ALAMEDA COUNTY
HEALTH CARE SERVICES

Subject: Fuel Leak Case No. RO0002440, Bernard's Gas, 1051 Airway Blvd., Livermore, CA -
Work Plan Approval

Alameda County Environmental Health (ACEH) staff has reviewed the fuel leak case file for the above-referenced site and the document entitled, "Workplan for Monitoring Well Installation Addendum," dated April 14, 2006 and prepared on your behalf by Apex Envirotech, Inc. The Work Plan Addendum proposes the installation of seven shallow and one deeper monitoring well to investigate the extent of contamination at the site.

SITE PLAN MAP

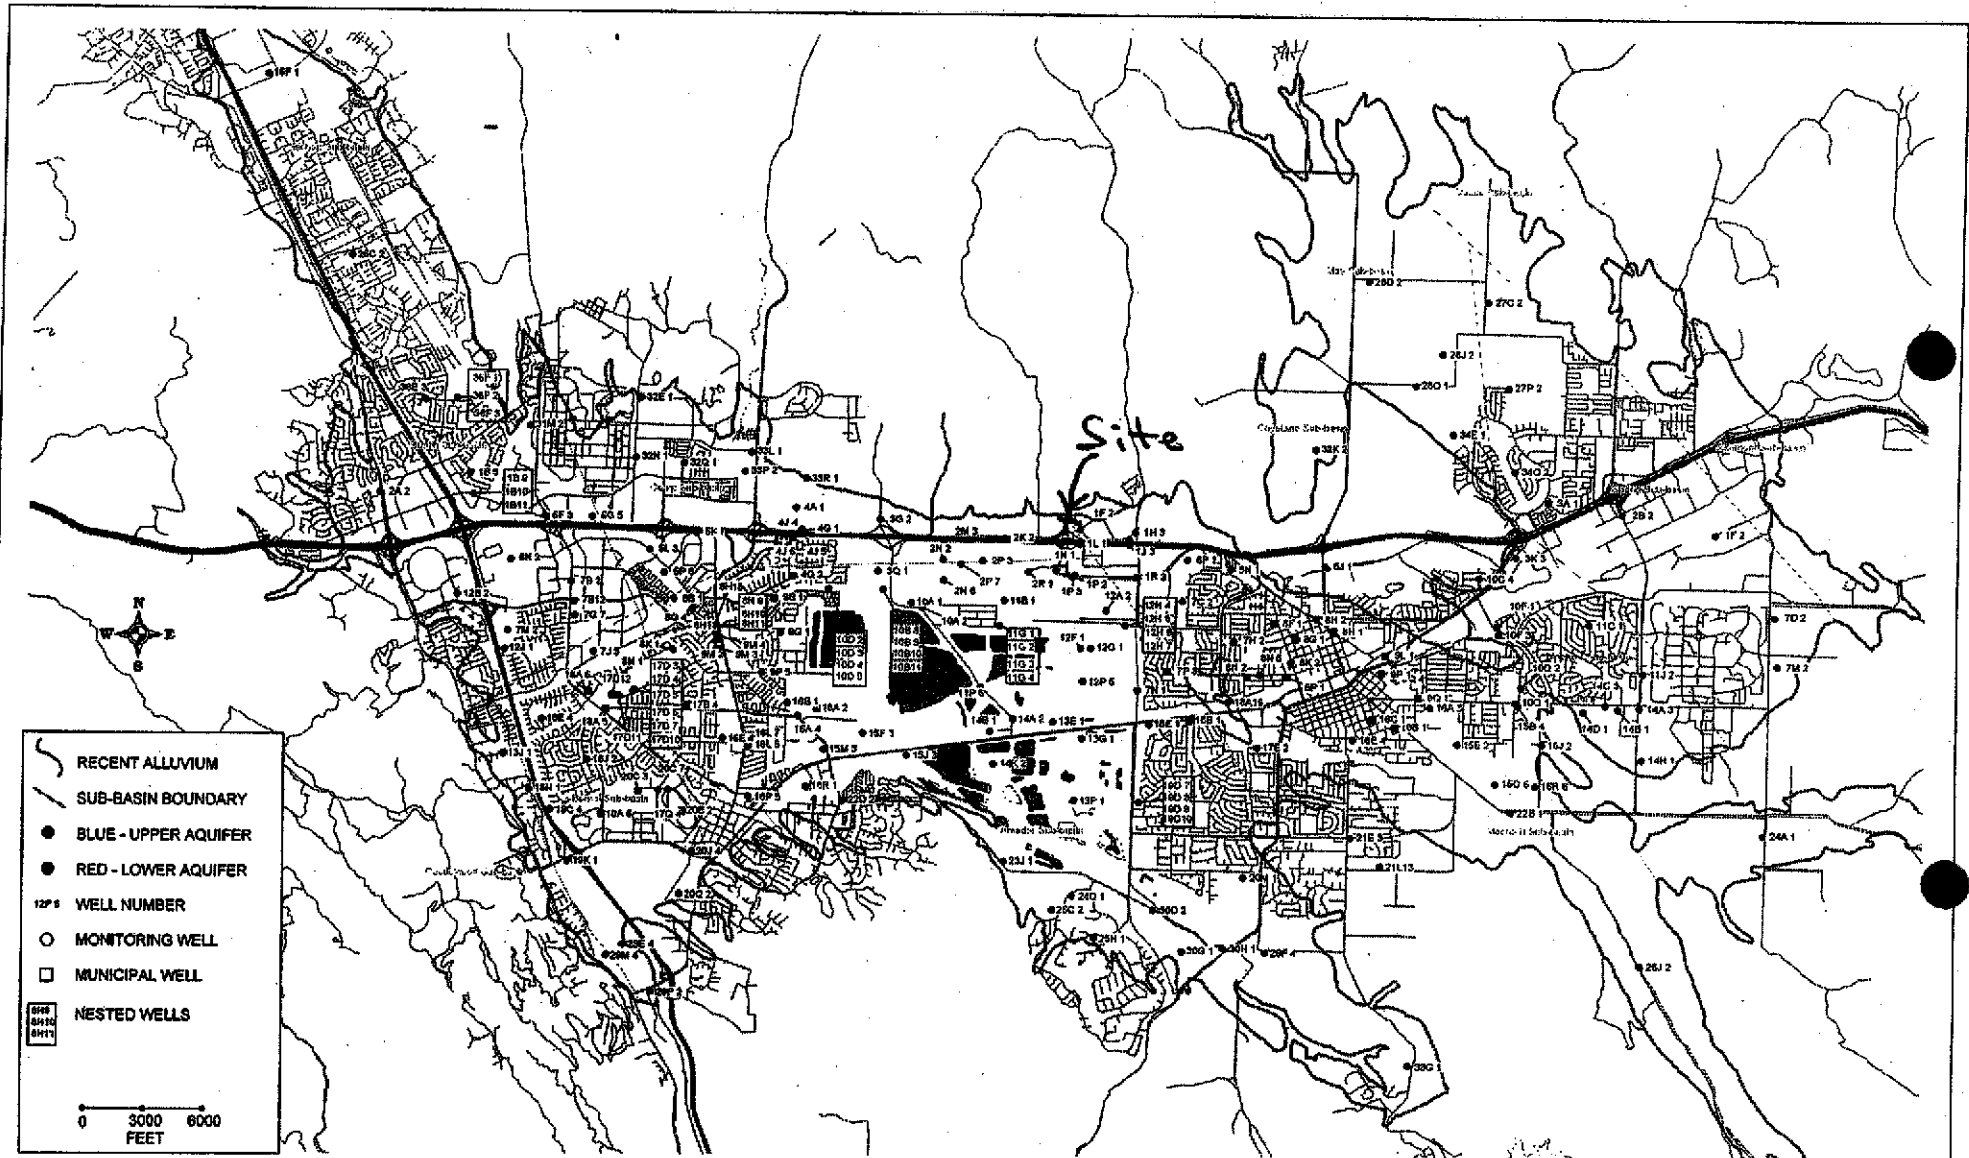
3. **Proposed Well Locations.** On the attached figure, please see the suggested revisions to the proposed monitoring well locations. ACEH also requests that an additional shallow monitoring well be installed adjacent to the proposed deep monitoring well, MW-5.

DRAWN BY: J. Curry	SITE PLAN MAP	FIGURE 2
	DATE: 10/04/05		
	REVISIONS	Bernard's Gas 1051 Airway Boulevard Livermore, California

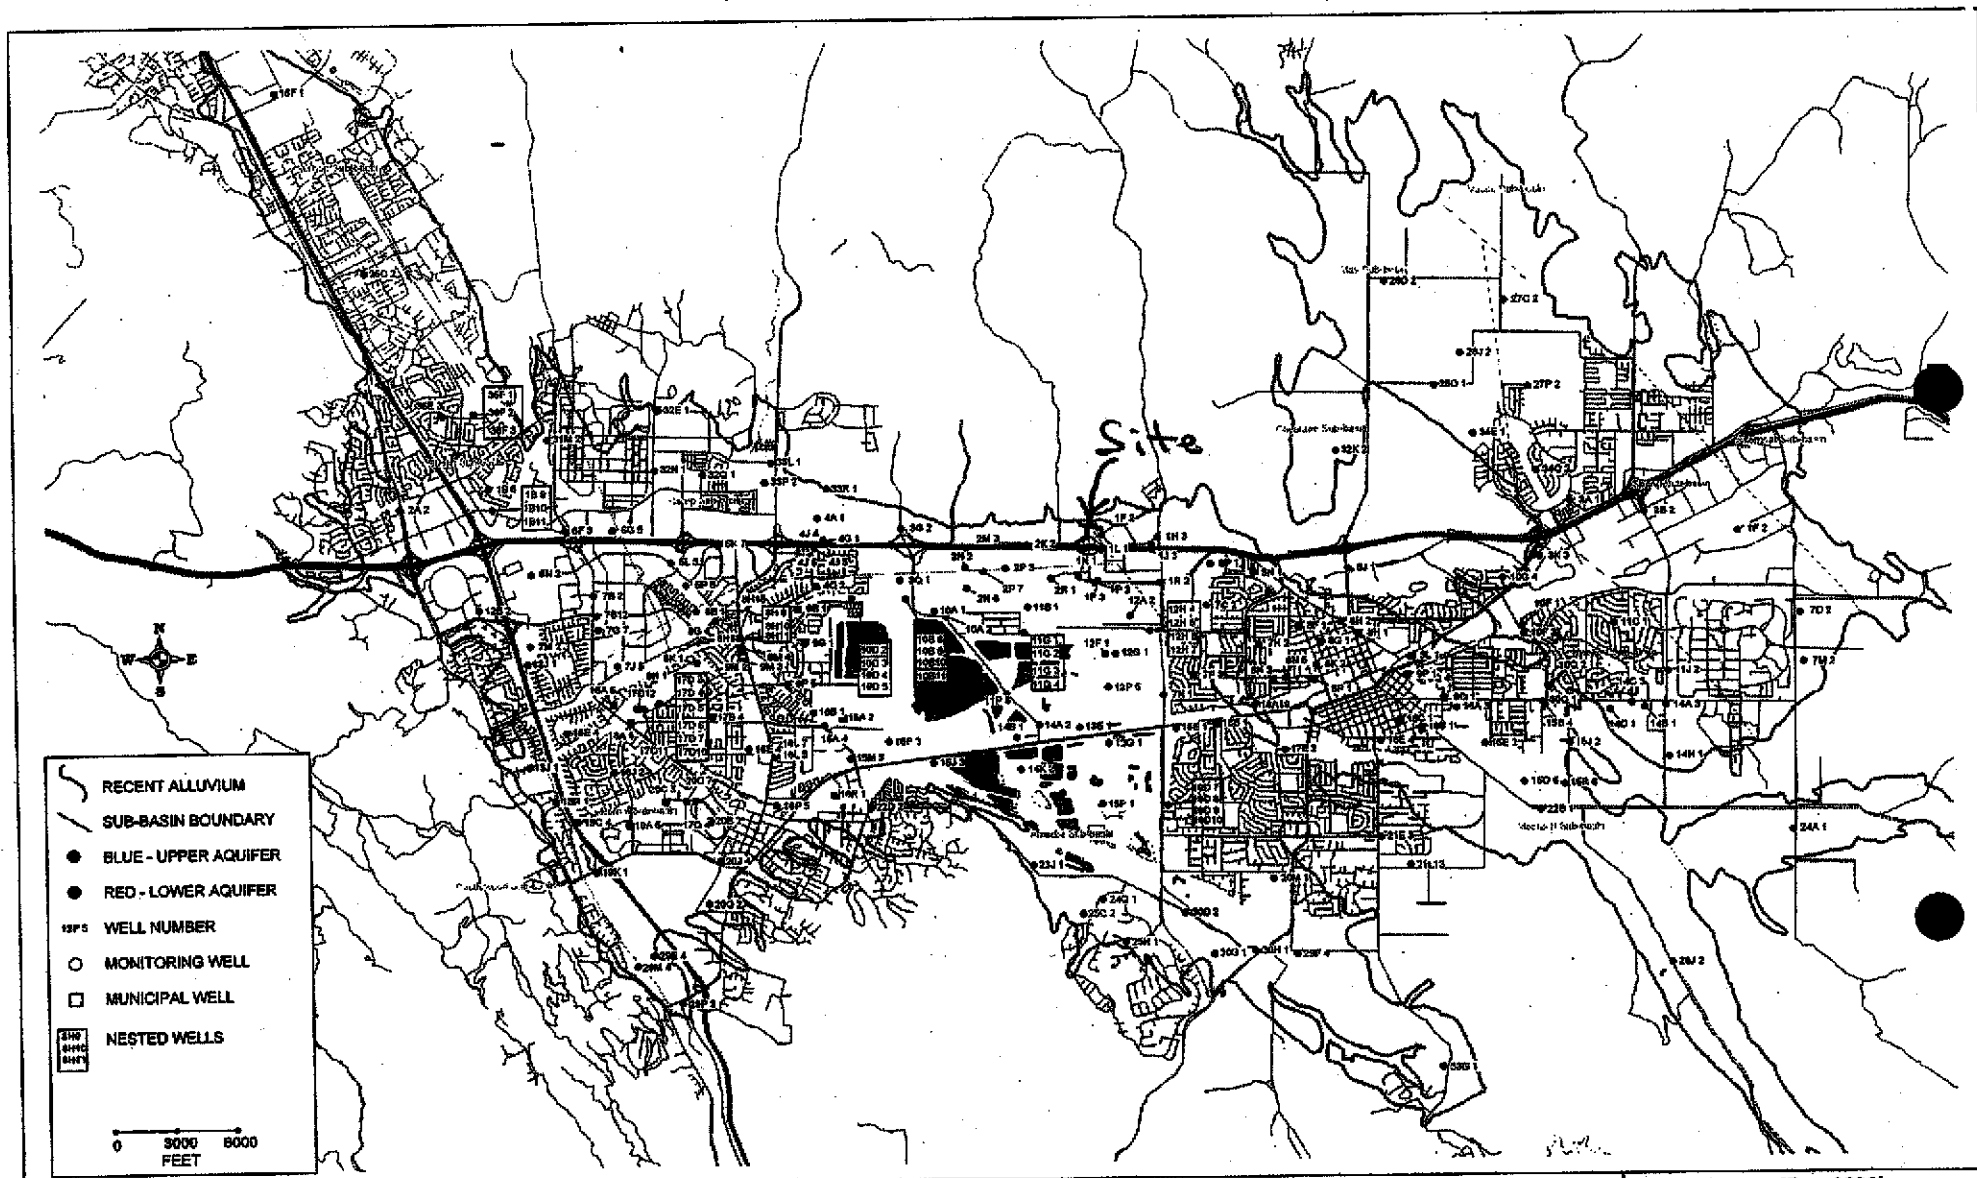
3. **Proposed Well Locations.** On the attached figure, please see the suggested revisions to the proposed monitoring well locations. ACEH also requests that an additional shallow monitoring well be installed adjacent to the proposed deep monitoring well, MW-5.
